**ADDENDUM # 10**

**WEGO Transit and Fleet Operations Center Expansion**

**Request for Proposal No: RFP-22-2024-AD**  
**Issue Date of Addendum: January 16, 2025**  
**Proposal Submission Deadline: January 23, 2025 at 2:00 p.m. ET**

**ADDENDUM No.2**

DRAWING TITLE:  
**SECOND FLOOR HVAC PLAN**

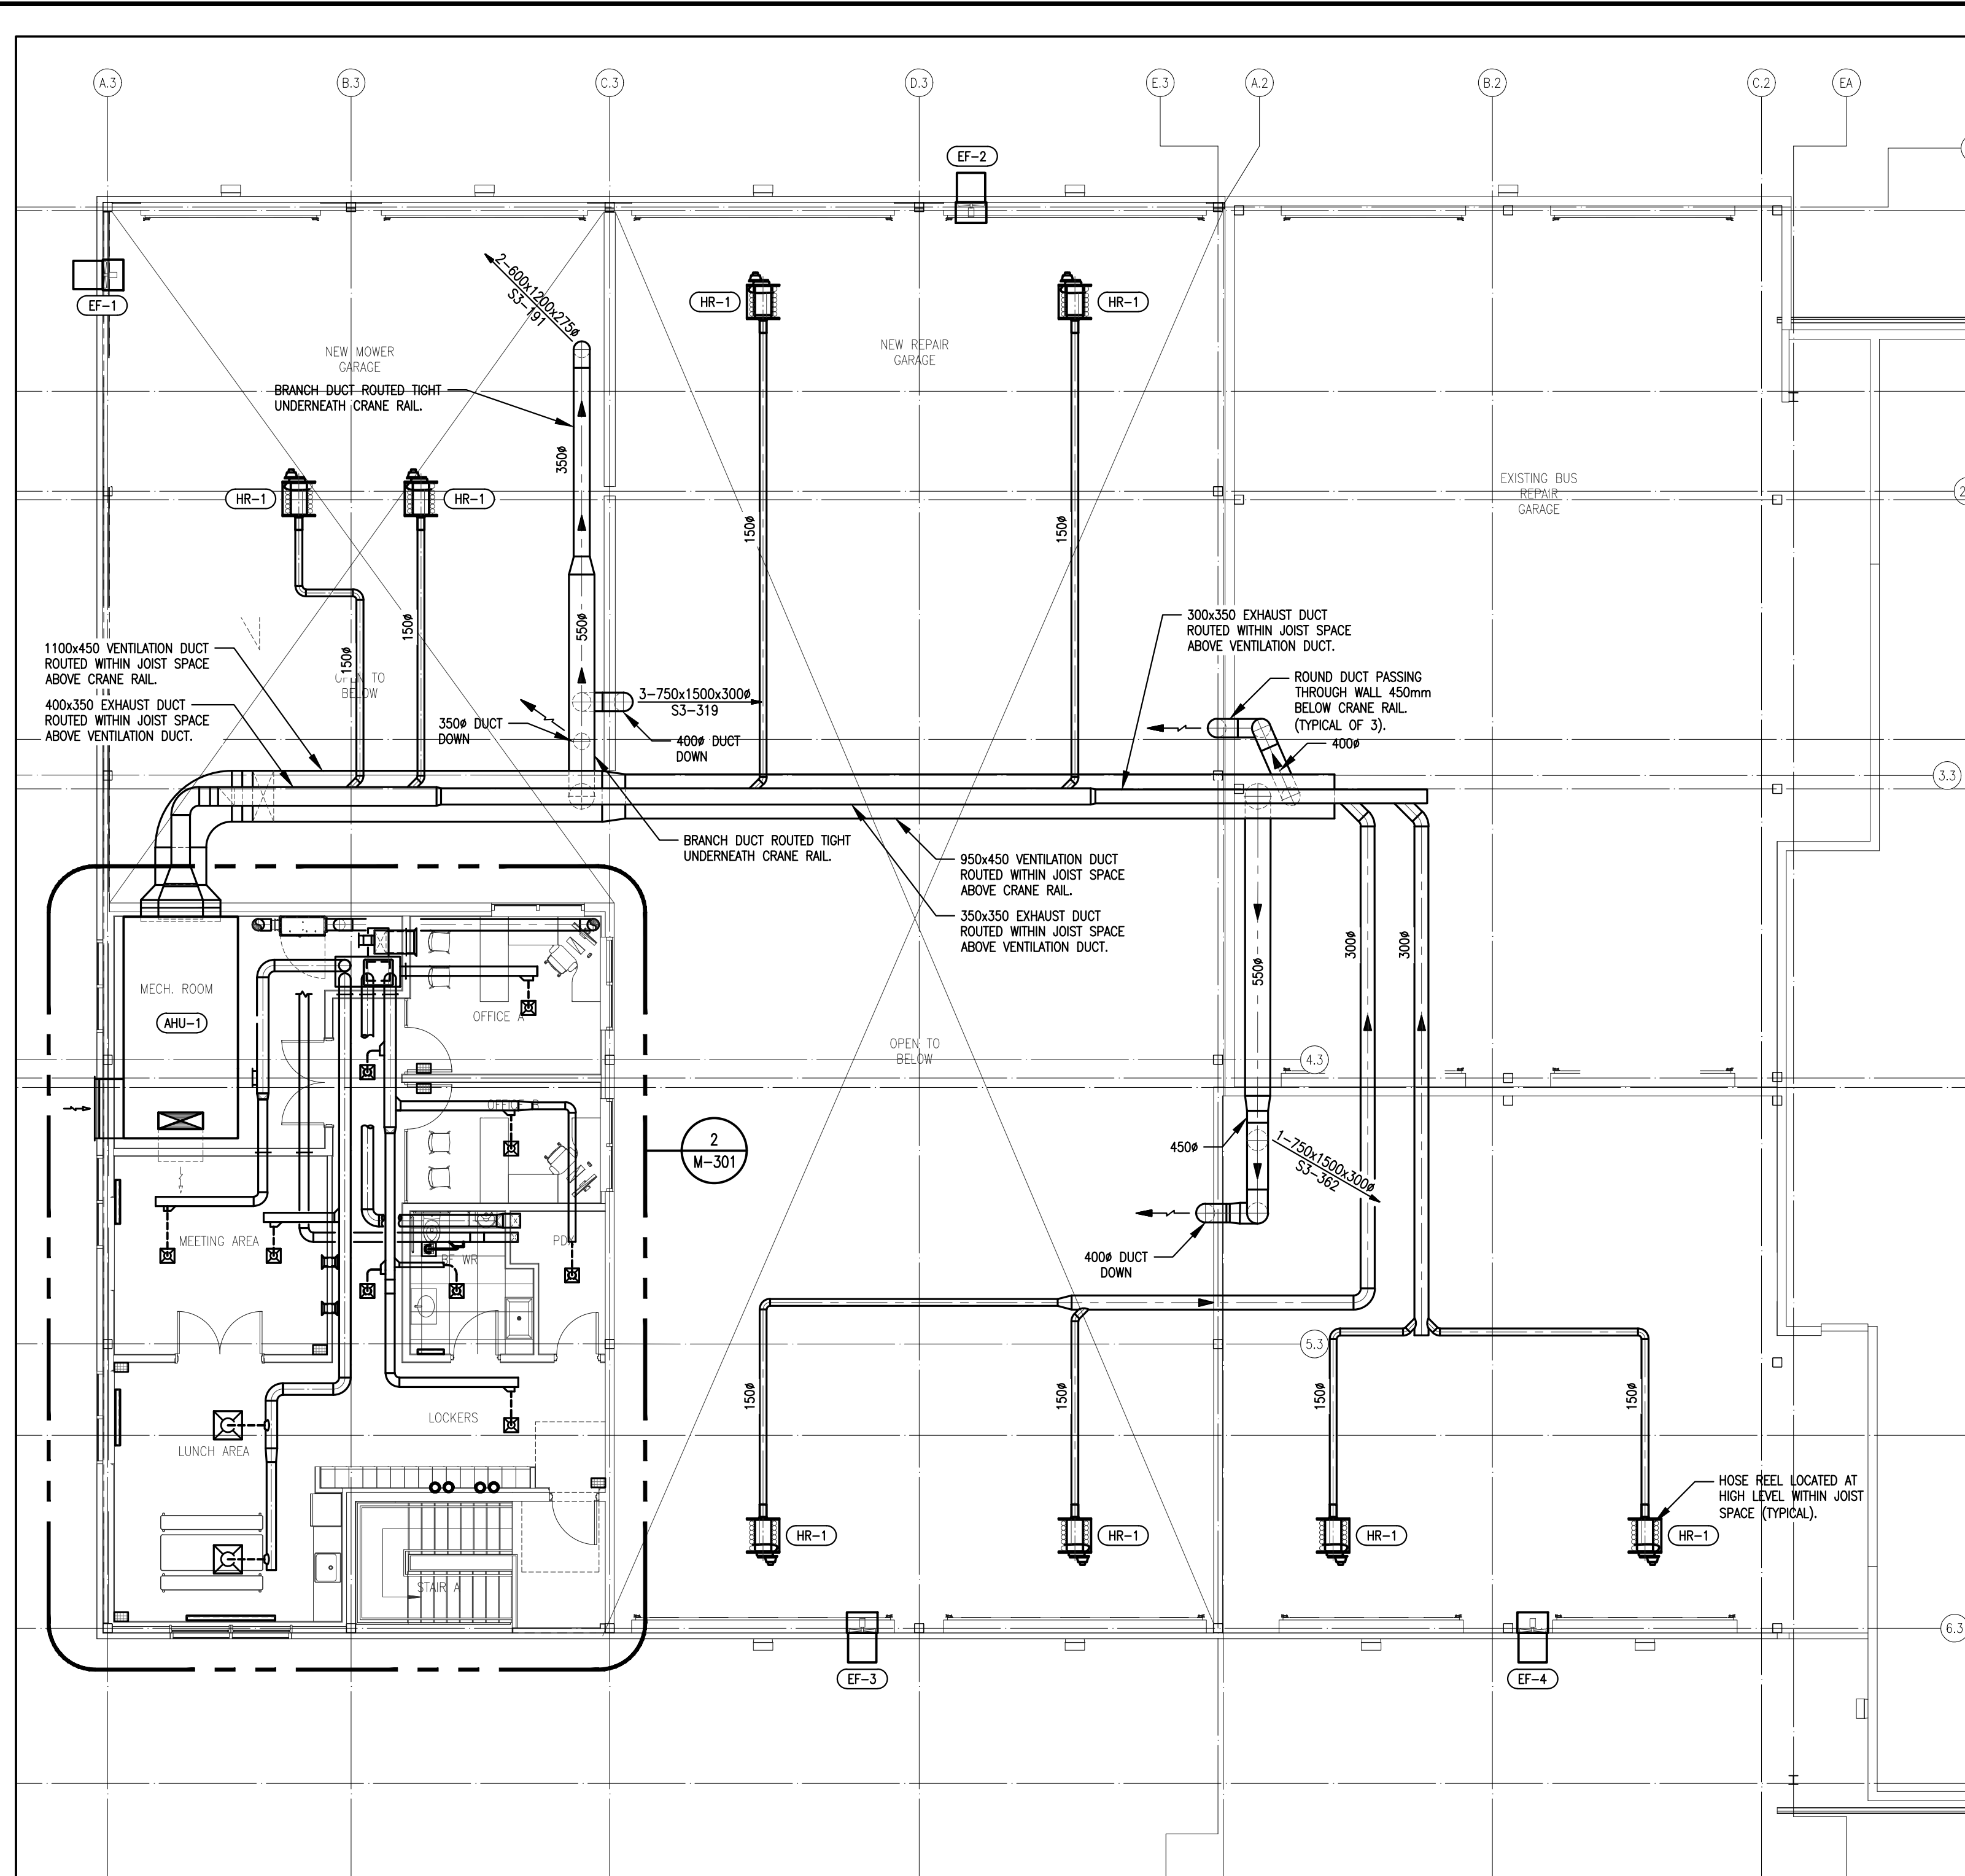
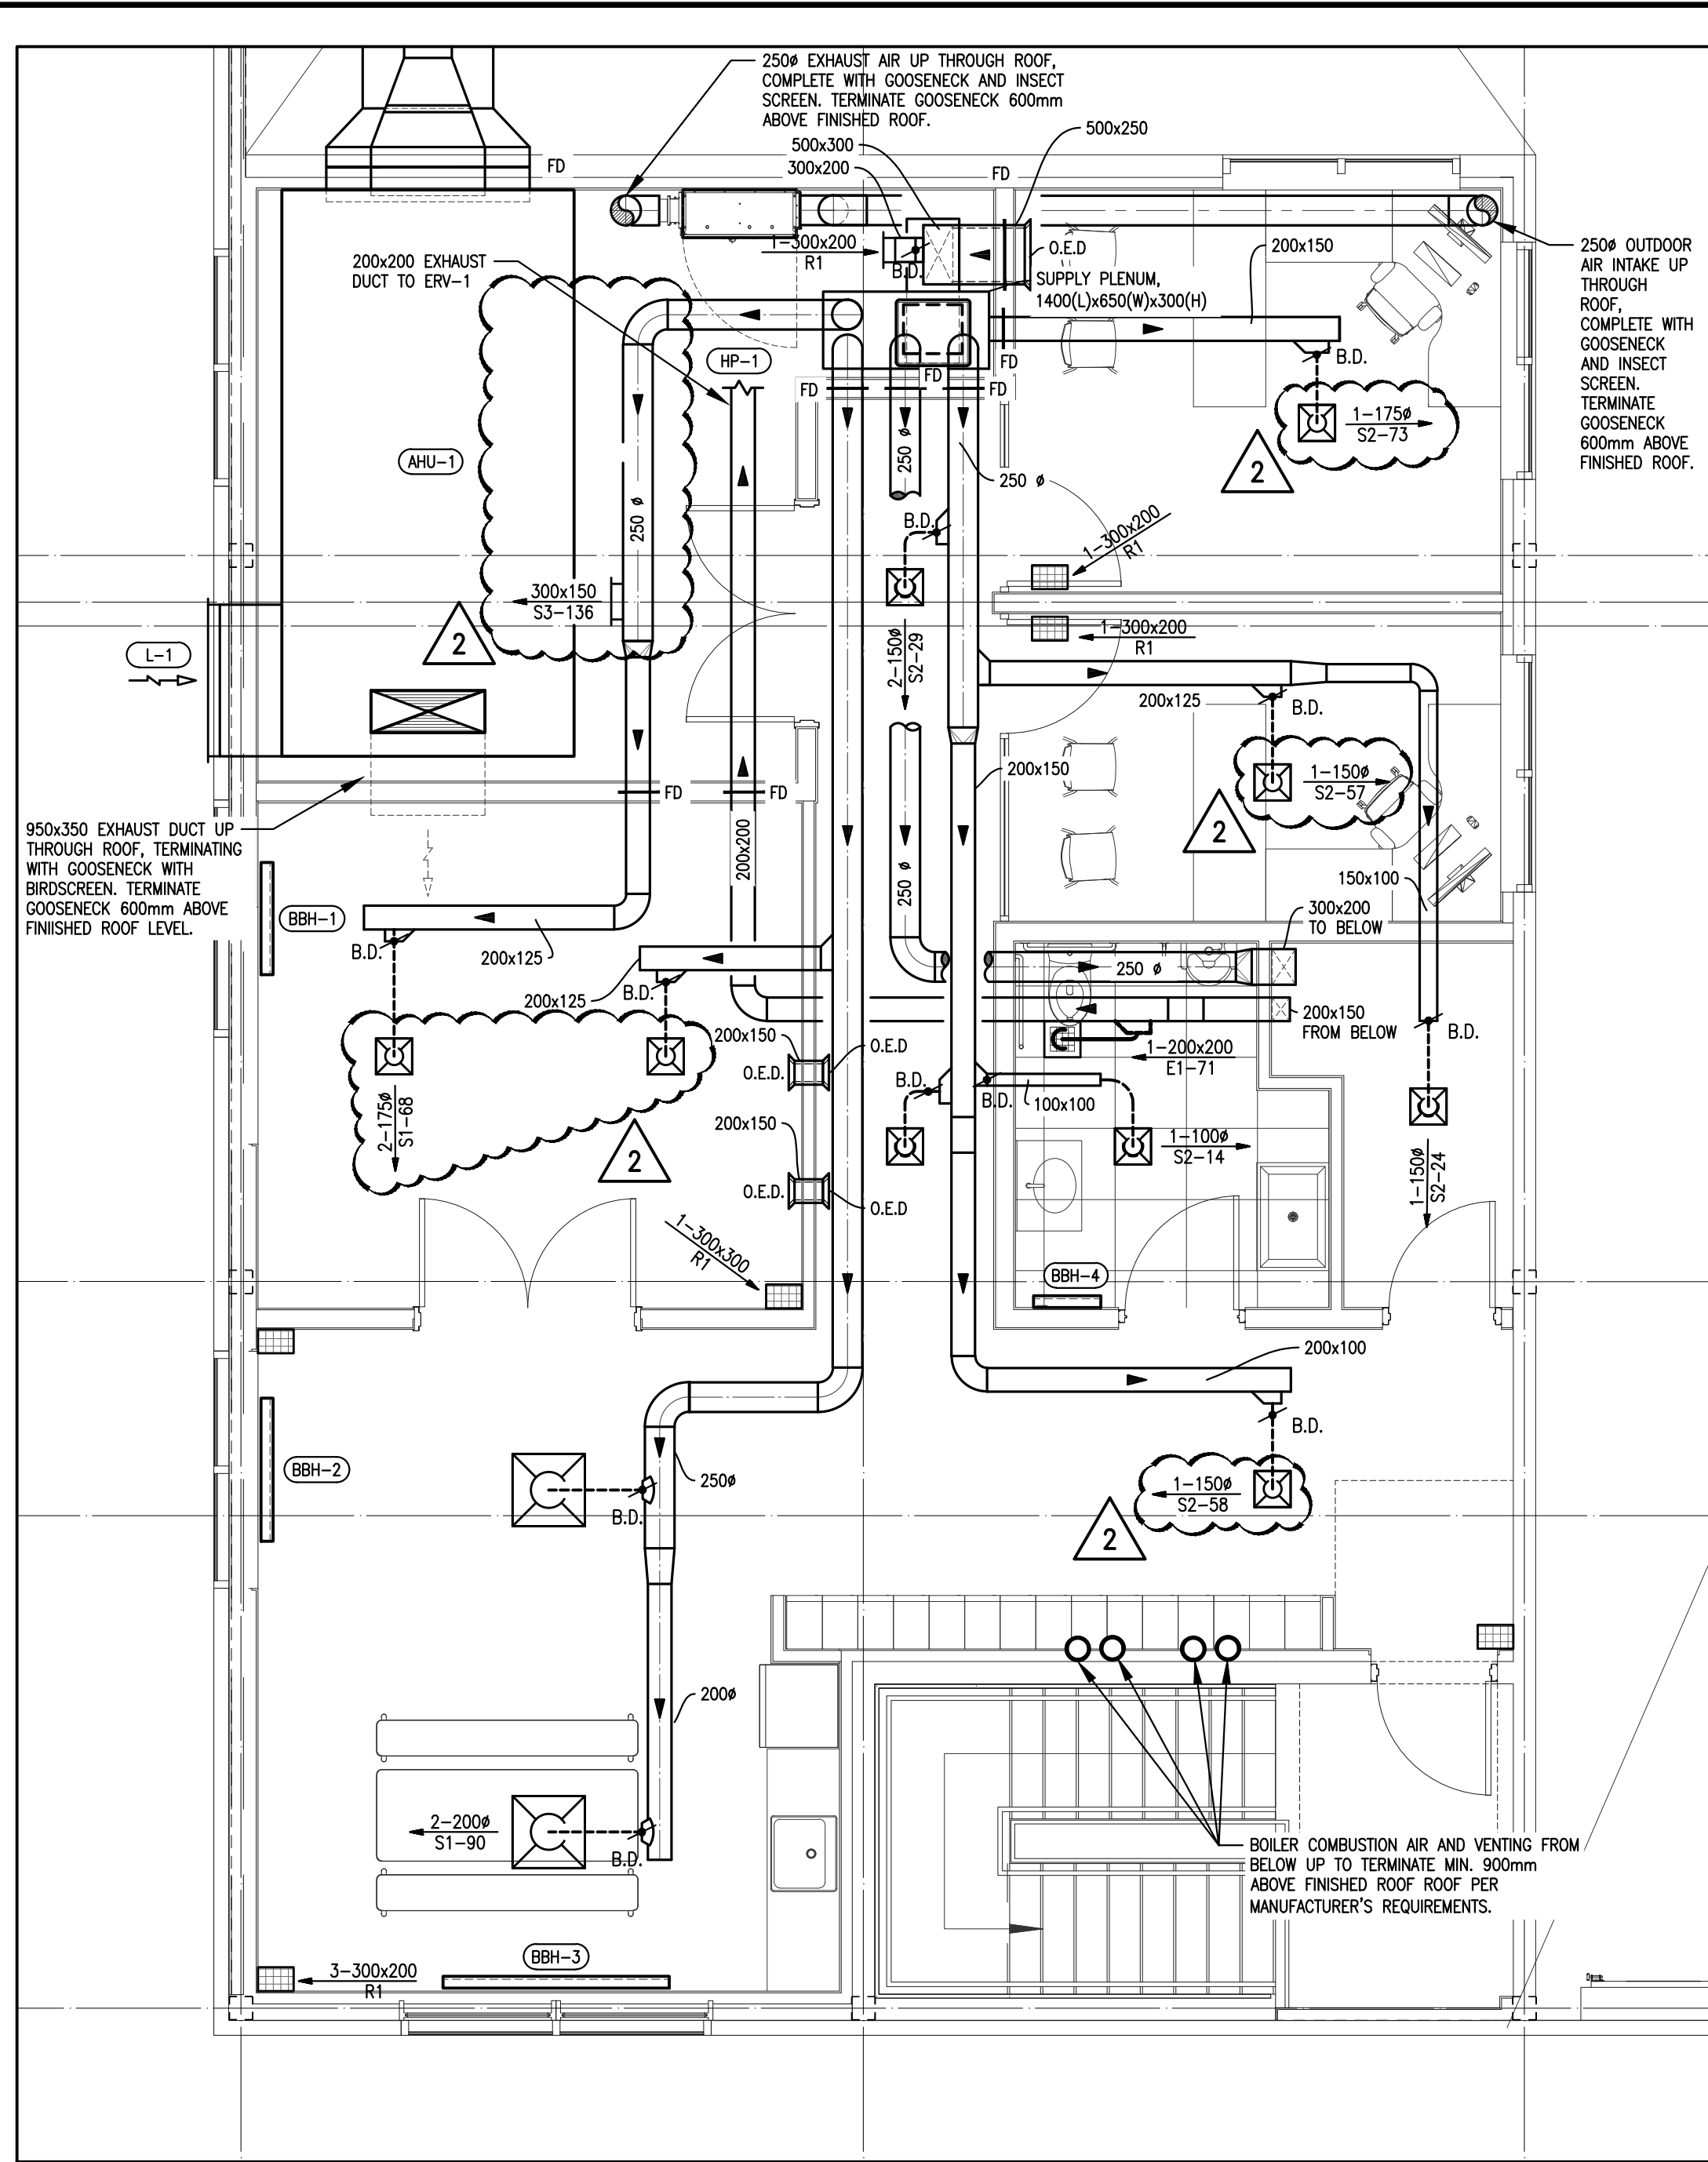
7	Drawing M-301, Rev 2 (re-issued)	<b>Second Floor Office Part Plan</b> - Removed Type S1 diffusers from mechanical room and replaced with Type S3 grille. - Revised several diffusers from Type S1 to Type S2

DRAWING TITLE:  
**MECHANICAL ROOF PLAN**

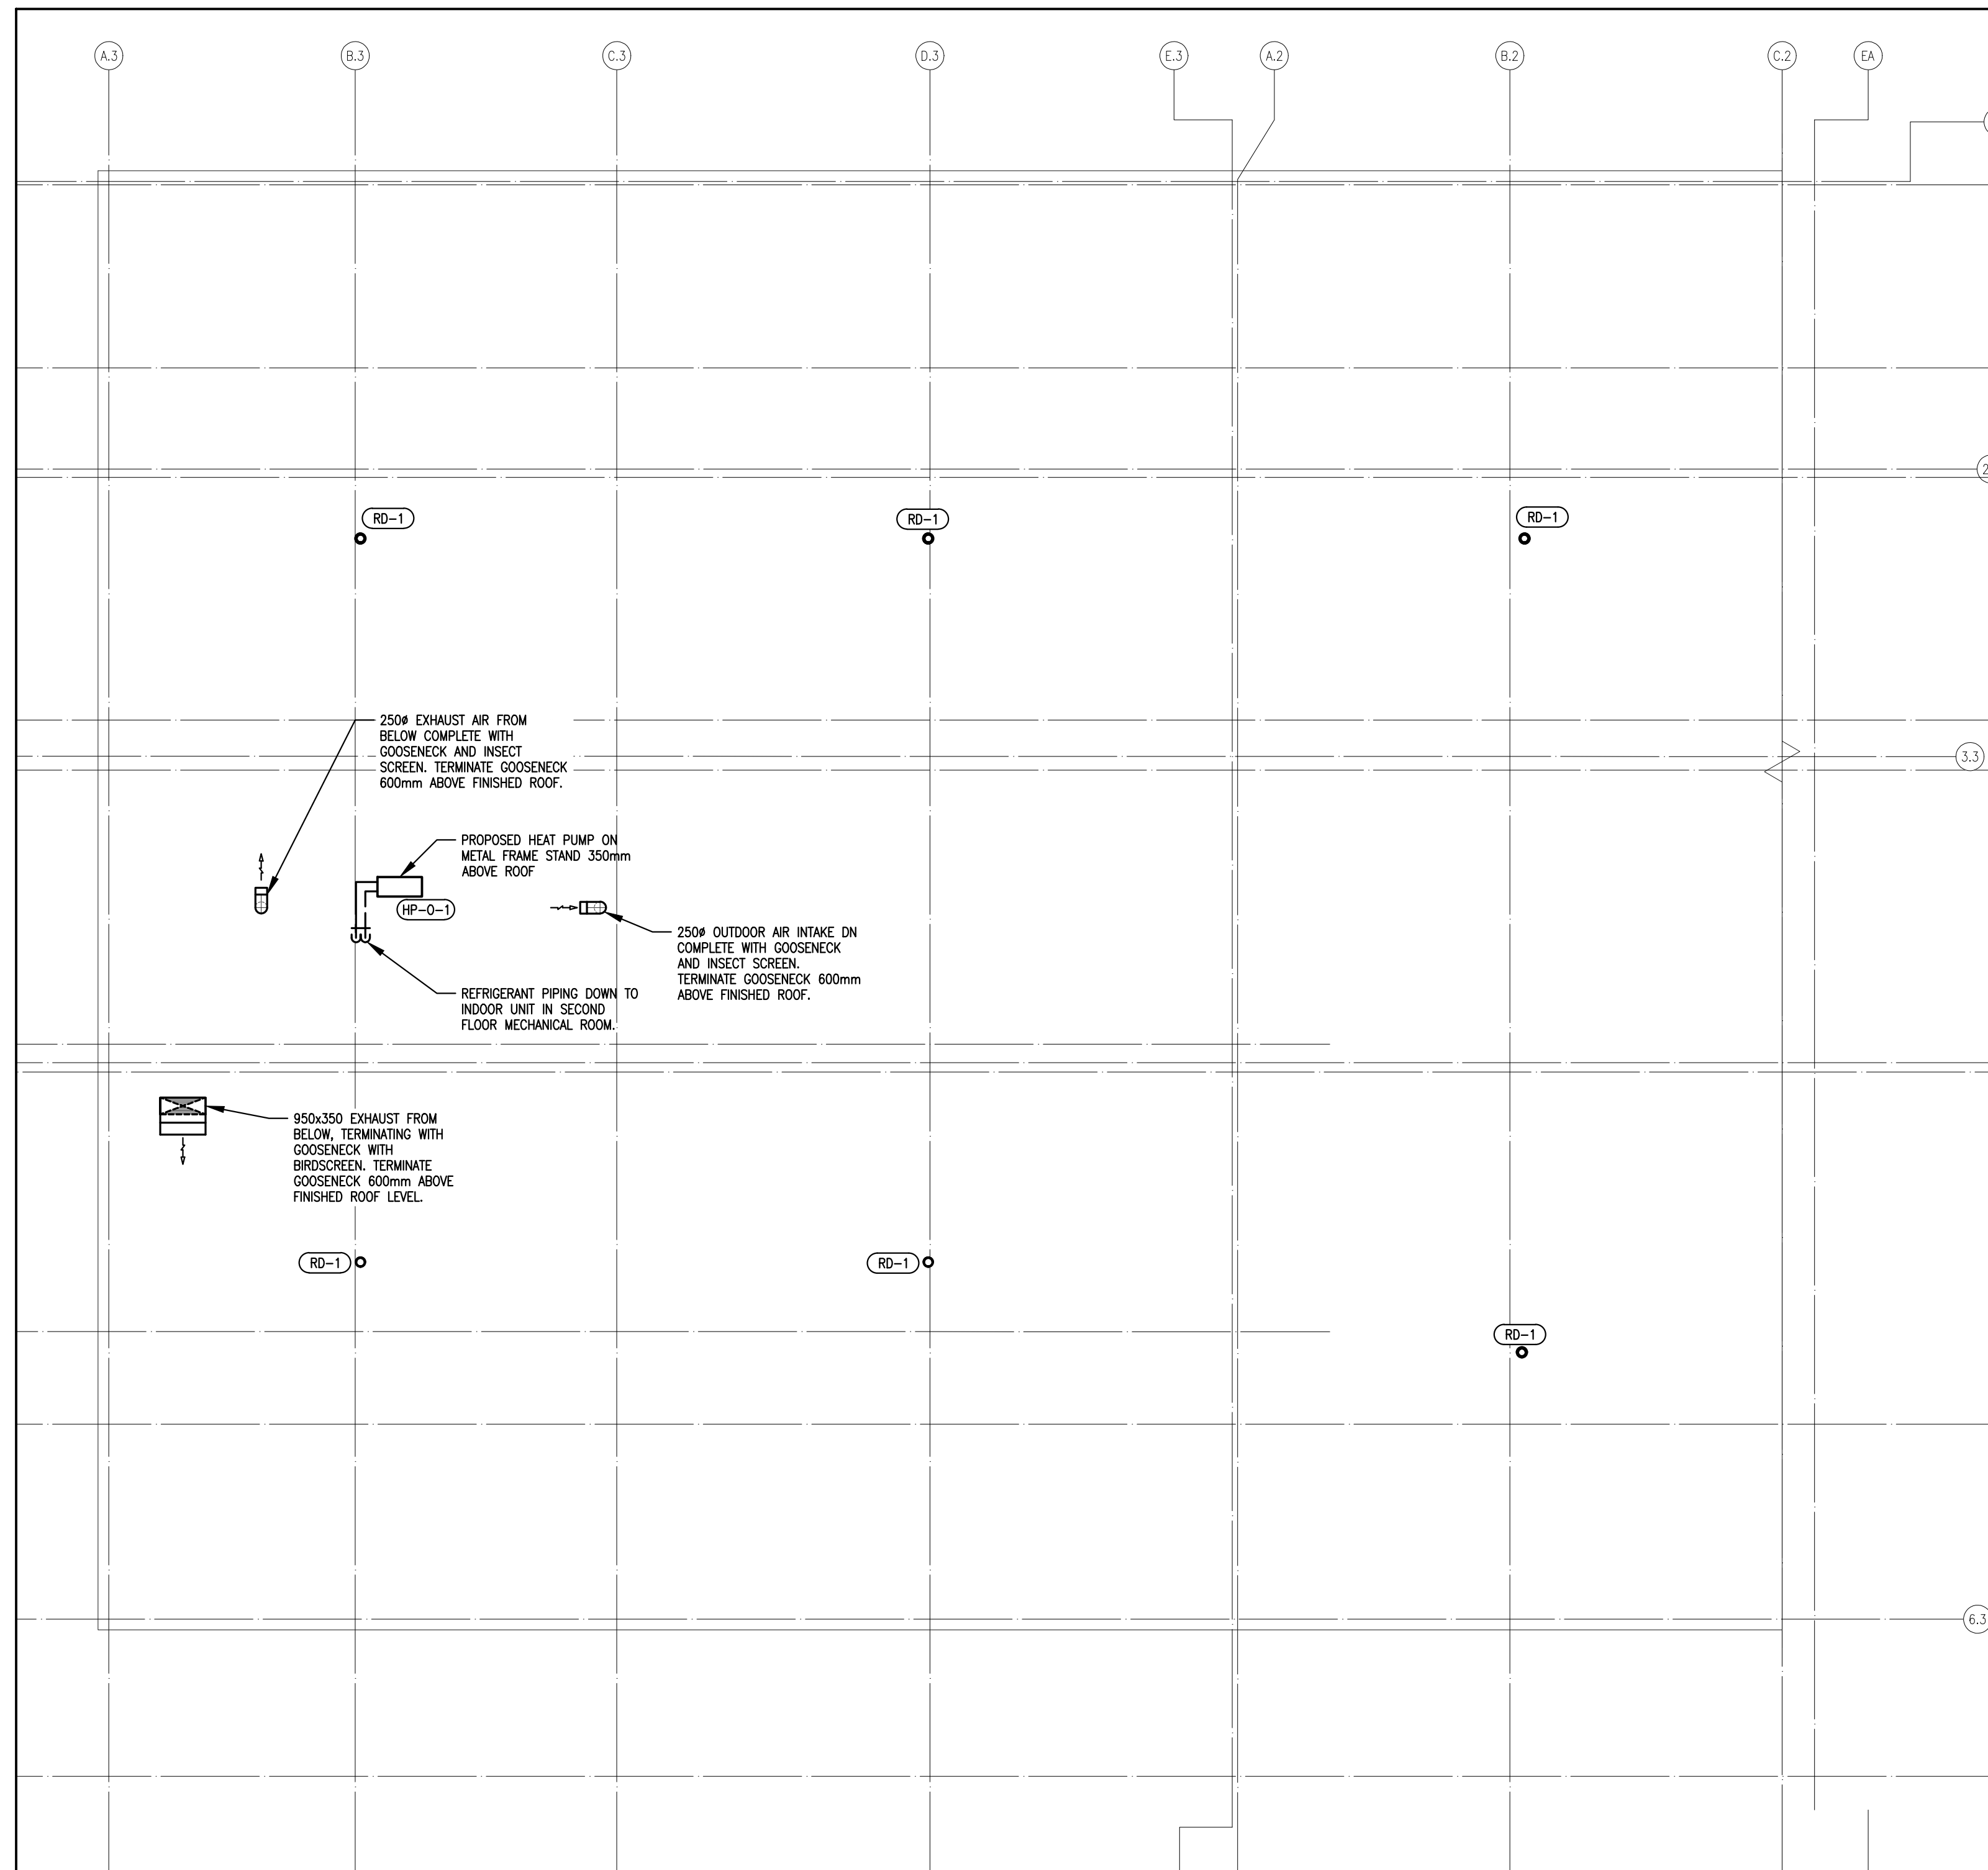
8	Drawing M-302, Rev 0 (issued)	<b>Mechanical Roof Plan</b> - Added roof plan detailing HVAC and roof drains
---	-------------------------------------	---
